Aqueous Solutions (owner) AQS-MFG-GLASS_RINSE-GA_SIDE
GLASS_RINSE fabrication drawing GA_SIDE (AQS-PLAN-006 M3; gr
Type: fabrication drawing (GA / nozzle orientation / part sheet) Rev 83ad2a70 Issued
Created: flow graph pipeline Approved: not approved (study)
Sheet 1 of 1 AQS-DWG-001

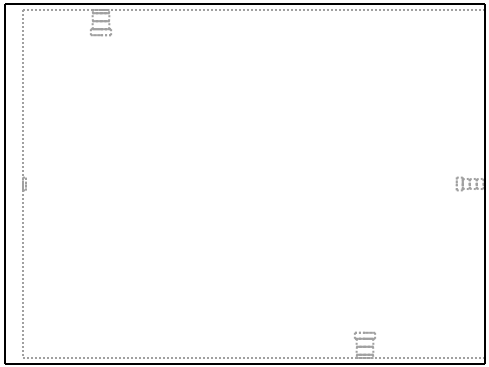
Graph revision AD - ga_side: Bath walls sit on the base head; the freeboard line sits 100 mm below the rim
Graph revision AD - ga_side: Dewater pump not drawn: no pump is named on the node or duty (hold, W12; the legacy form carried a DN80 pump hint only)
Graph revision AD - ga_side: Liquor leaves to SALT FEED, not the sewer (legacy form note carried by the line list)
